SERVICE BULLETIN

No. Q95a under BRAKES

CHASSIS AFFECTED ALLENTOWN ☒ HAYWARD ☒ OAKVILLE ☒**BRAKE INTENSIFIER**

PURPOSE To provide the field with procedure for changing intensifier pressure ratio from 23.5 to 1 to 17 to 1.

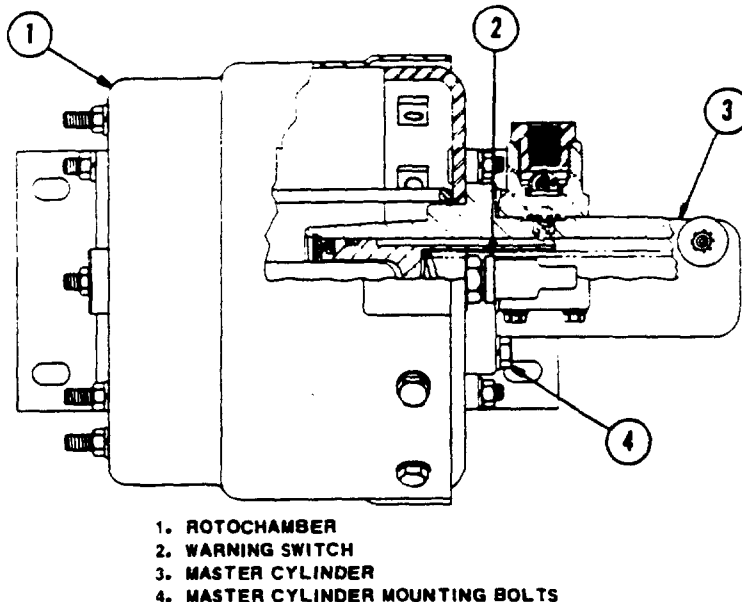
It is possible to convert a 23.5 to 1 intensifier to the 17 to 1 ratio by installing the smaller Rotochamber used on the low ratio unit. This latter method is less expensive and is recommended if the master cylinder is in good condition.

A switch is mounted on the chamber which actuates a warning light if there is a failure in the hydraulic system. This switch is the same for both intensifier ratios and can be transferred from old to new assembly. Part number of the switch is listed in case existing switch is not useable.

Procedure - Refer to illustration

The intensifier can be removed from chassis as an assembly, or in many cases, the Rotochamber can be separated from the master cylinder without removing cylinder from chassis or disconnecting the hydraulic line. Where space permits, the latter procedure is recommended as it eliminates necessity of bleeding the hydraulic system. It is important to support the master cylinder by some other means if it is left in the chassis, to prevent damaging the hydraulic line.

Regardless of which method is used, first disconnect air line from Rotochamber. If the master cylinder and Rotochamber are to be removed as an assembly also disconnect the hydraulic line from master cylinder. The intensifier can be removed as an assembly at this point by unbolting mounting brackets from frame.

If the master cylinder is to be left in chassis, remove the four master cylinder mounting bolts. Unbolt both mounting brackets from frame and slide Rotochamber away from master cylinder.

After old Rotochamber is separated from master cylinder, transfer mounting brackets and warning switch to new Rotochamber. If old switch is not useable, install a new one.

Assemble Rotochamber to master cylinder (either on or off chassis) and secure to frame. Connect air line and charge air system. If hydraulic line was disconnected, reconnect it and bleed hydraulic system.
